# STATE OF OHIO DEPARTMENT OF TRANSPORTATION

## FAY-435-1.52 WATER/SEWER RELOCATIONS (BU-2)

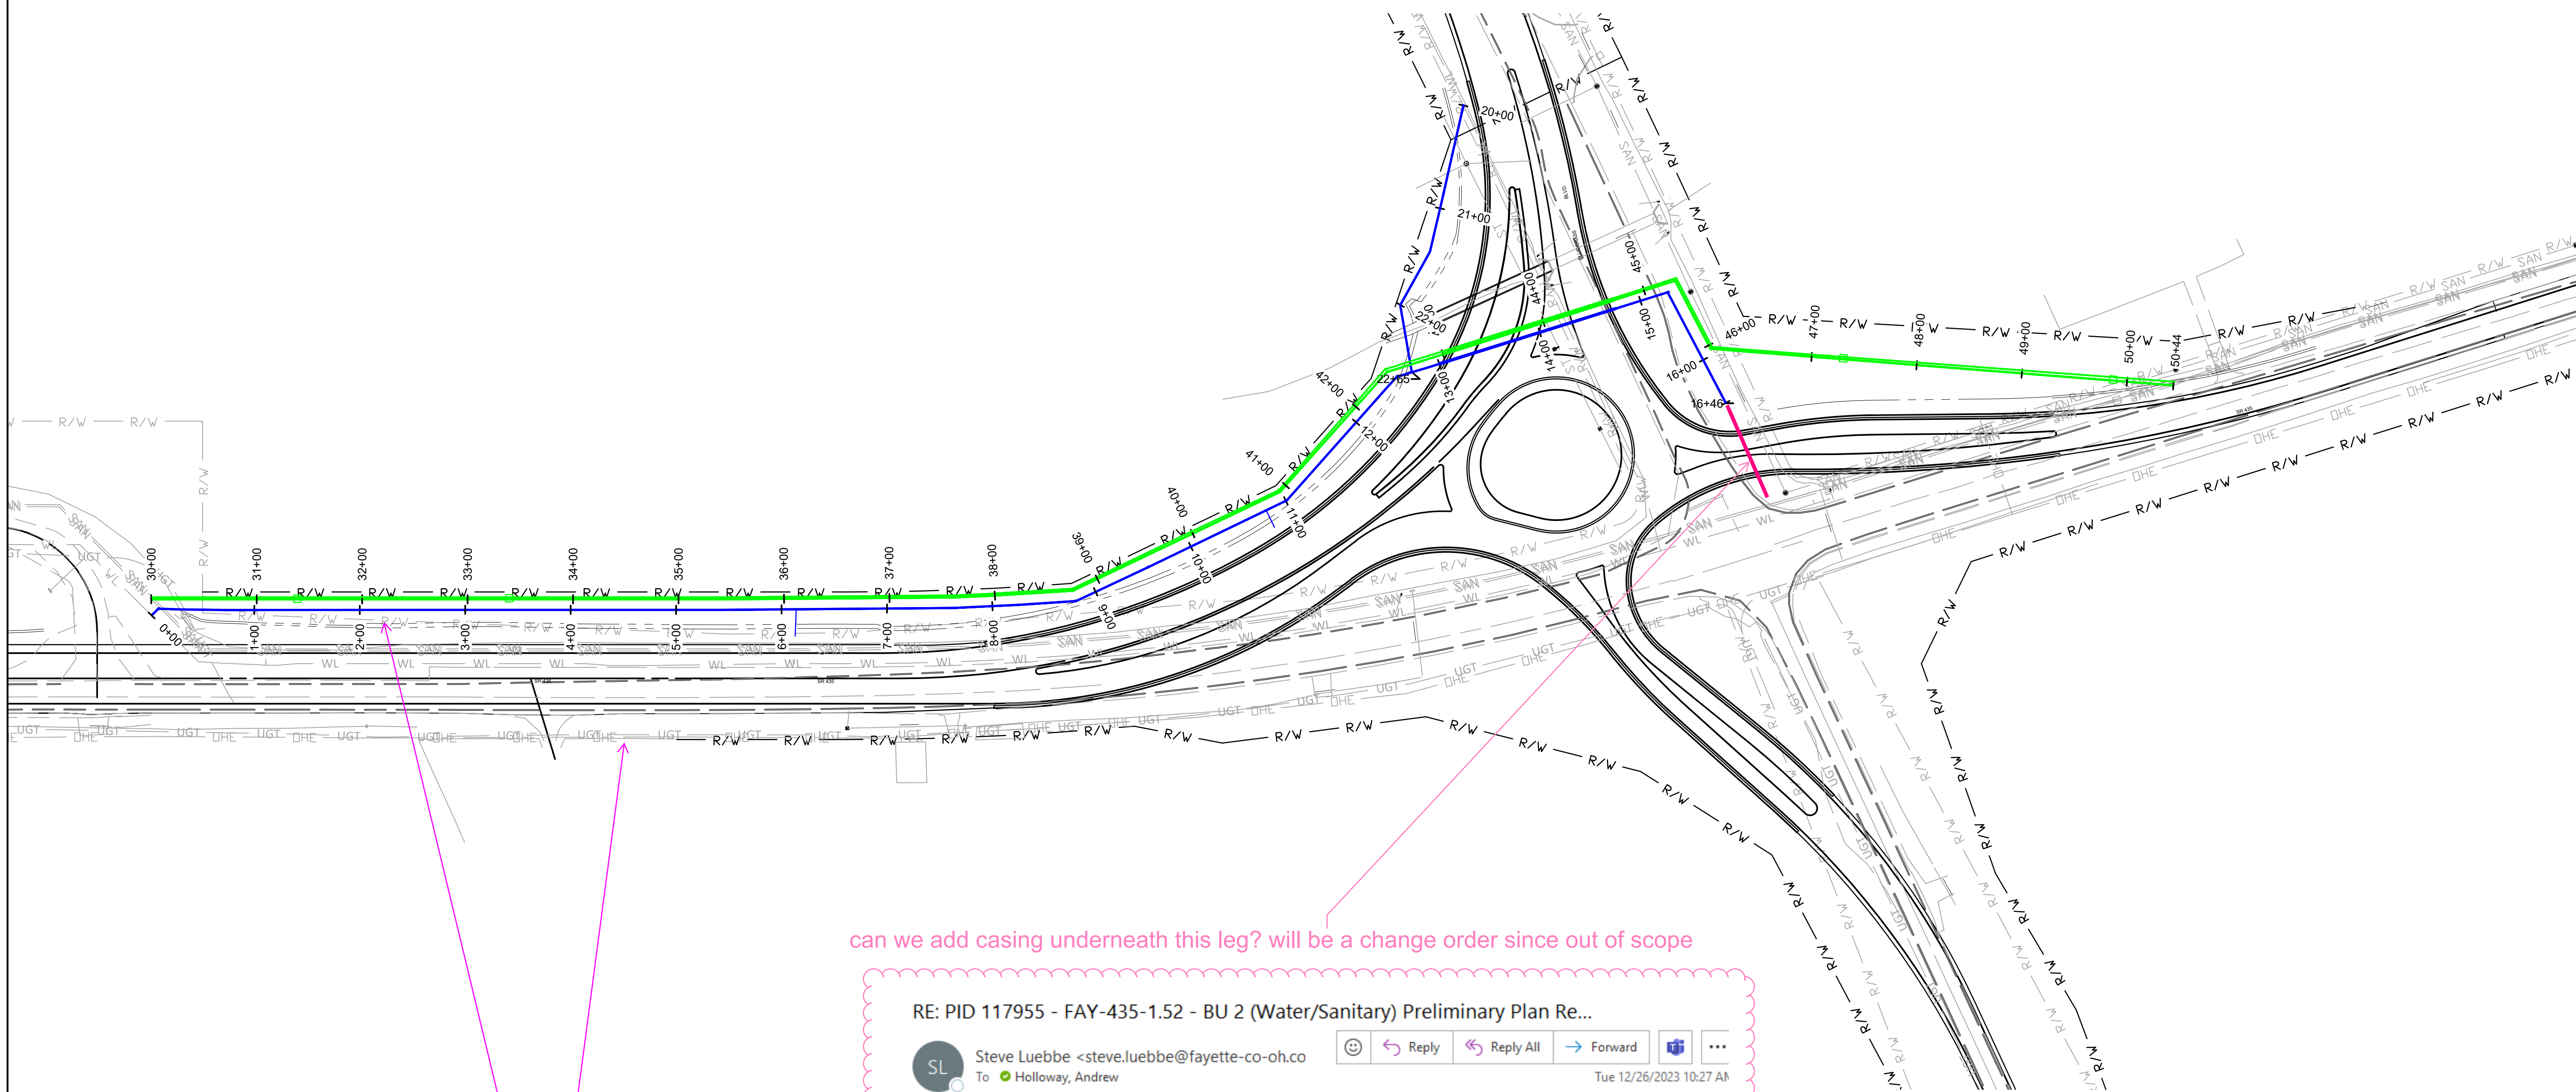
can we add casing underneath this leg? will be a change order since out of scope
